Technical change to M12 L-coded

- Product change notification number:	PCN-PB46-20200708-00-A
- date of publishing:	13. July 2020
- revision number:	A

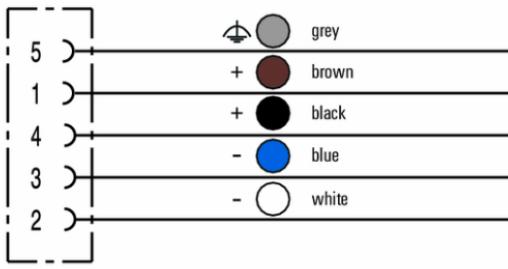
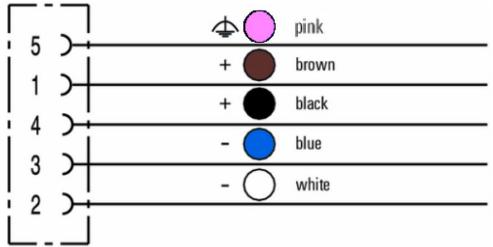
The wire colour of the functional earth (Pin5) changes from grey to pink.

The scope of this change is a result of an update to standard DIN EN 60445 (VDE 0197):2018-02 EN 60445:2017. The update will result in a change from a grey to pink wire color for FE (functional earth).
